FINAL

INVESTIGATION DATA SUMMARY REPORT

**JORGENSEN FORGE FACILITY
8531 EAST MARGINAL WAY SOUTH
SEATTLE, WASHINGTON
U.S. EPA DOCKET NO. CERCLA 10-2003-0111**

Figure 3
 Current Site Stormwater Drainage Plan
 Jorgensen Forge Facility
 8531 East Marginal Way South
 Seattle, Washington

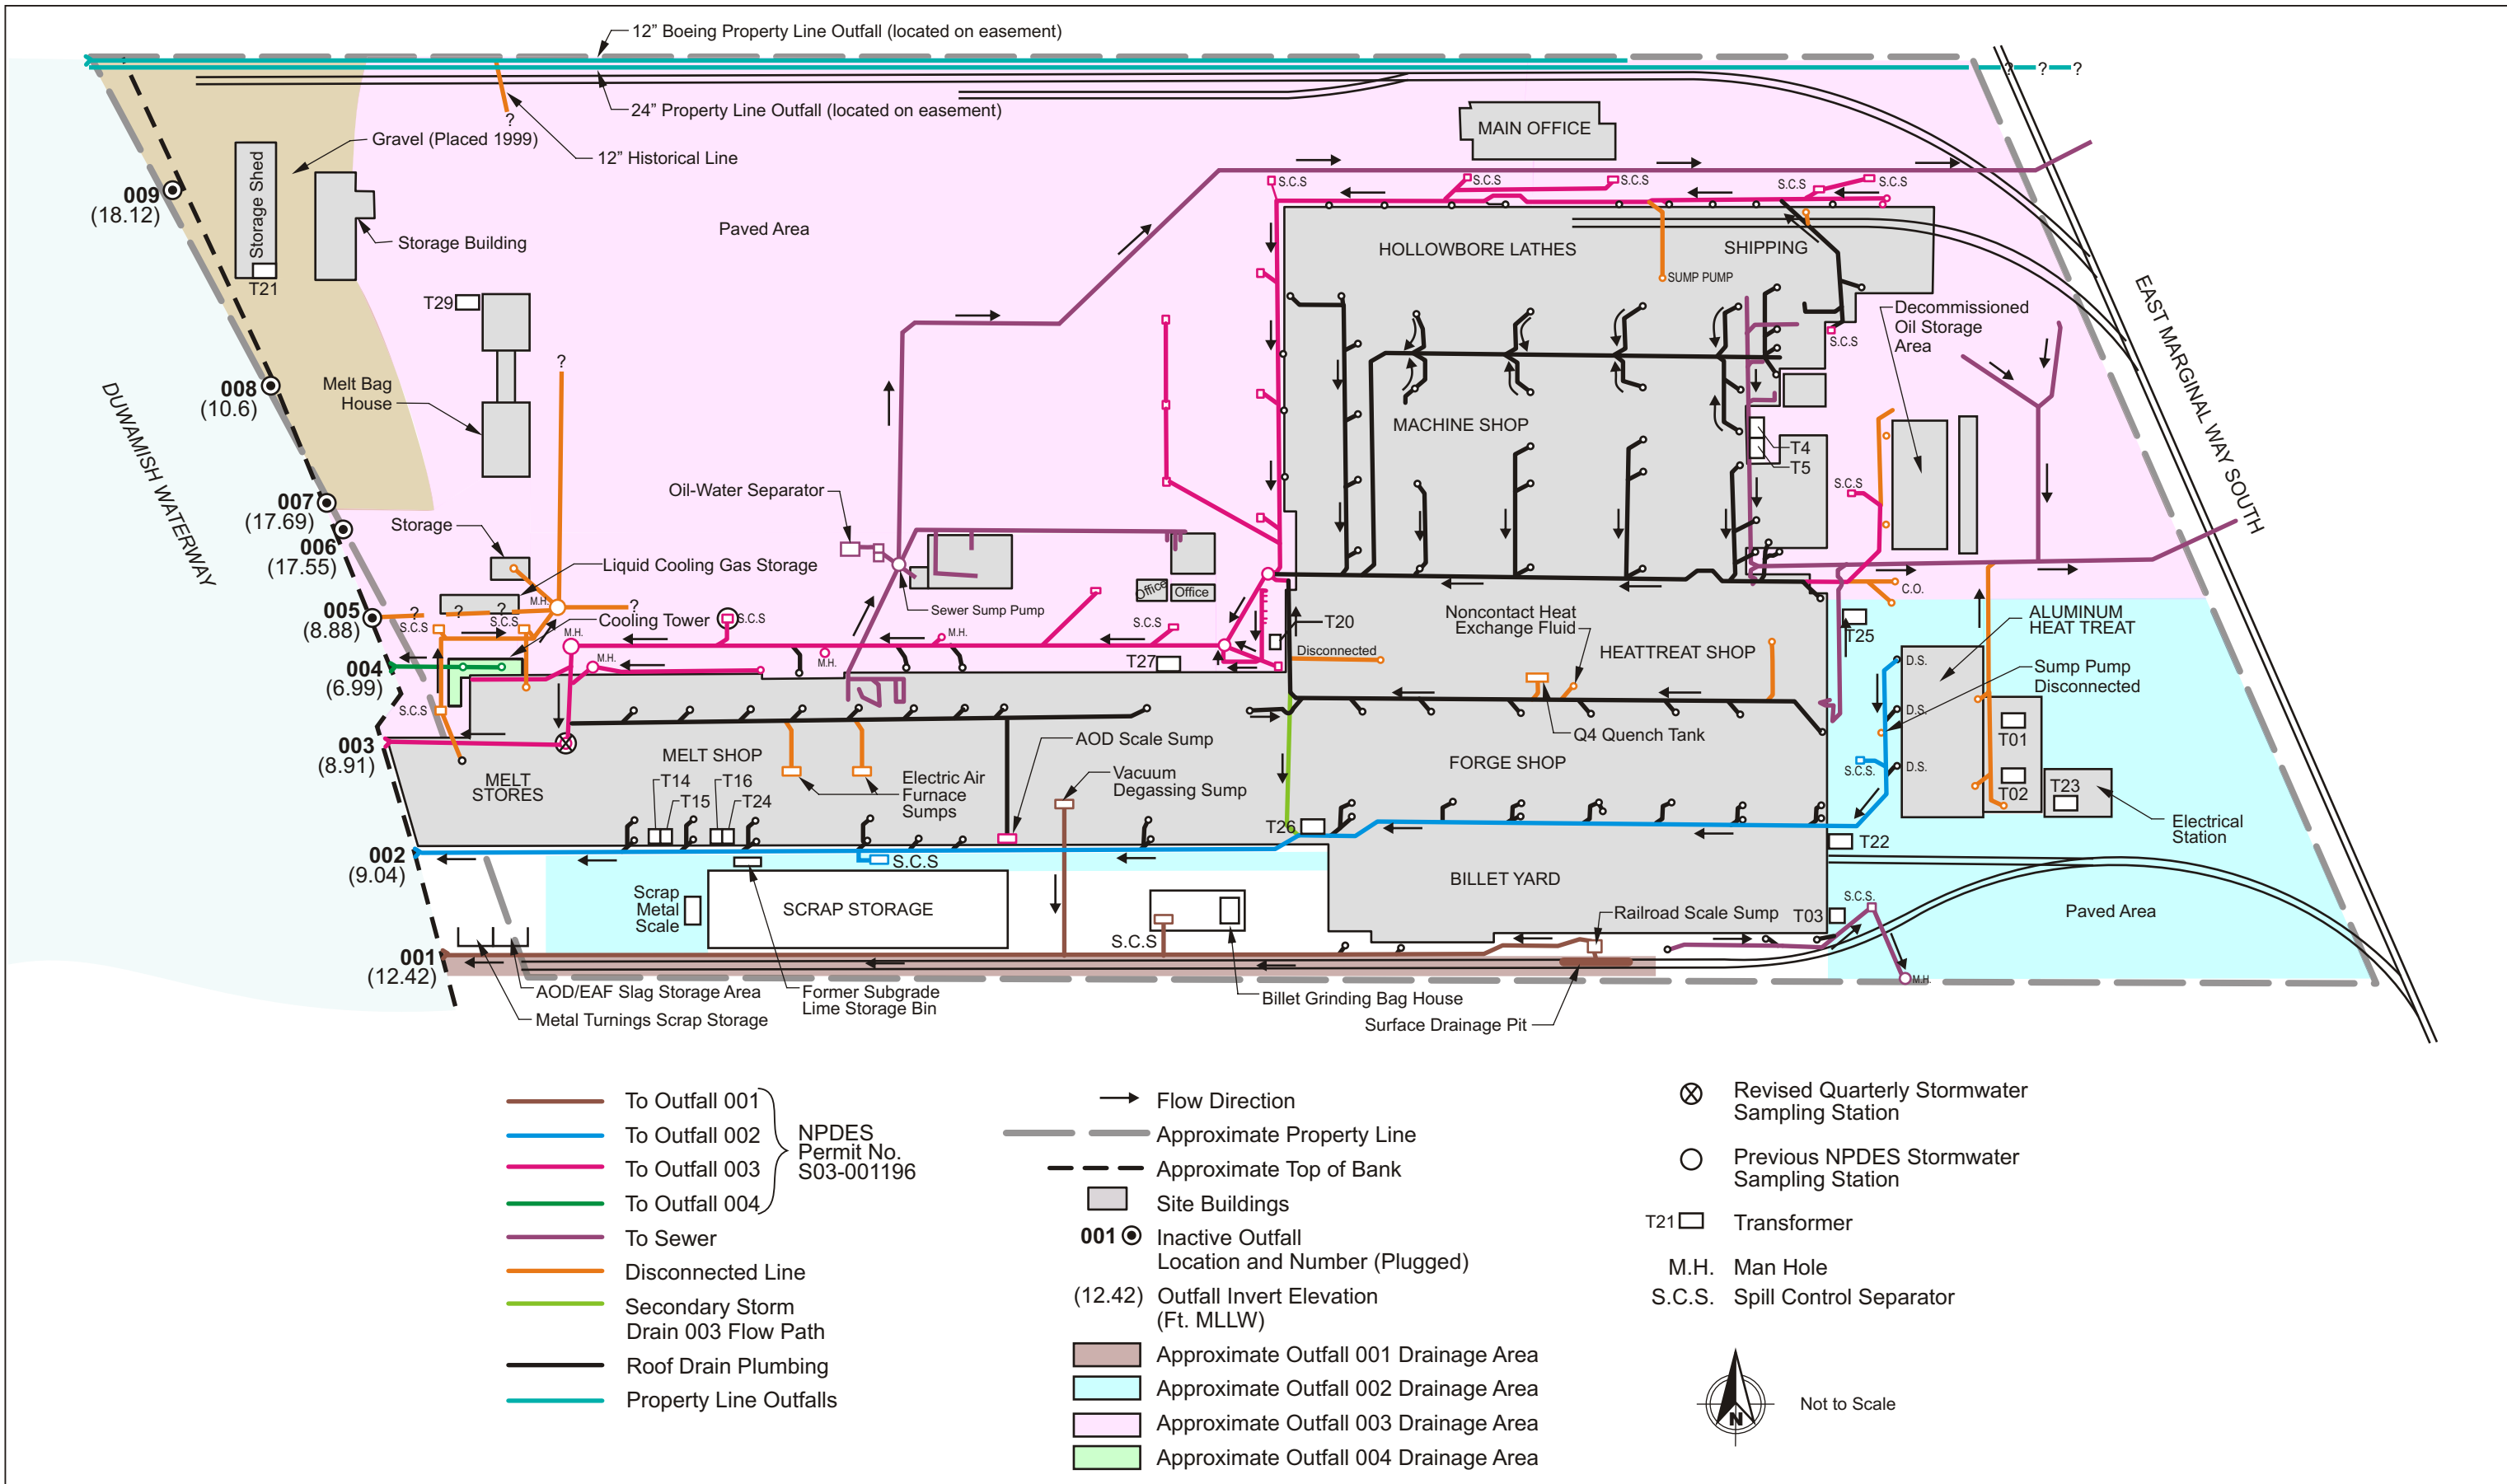
The last sentence on this page is not consistent with Figure 3 which shows that most of the drainage goes to Outfalls 02 and 03. The text must be clarified.

The last sentence on this page is not consistent with Figure 3 which shows that most of the drainage goes to Outfalls 02 and 03. The text must be clarified.
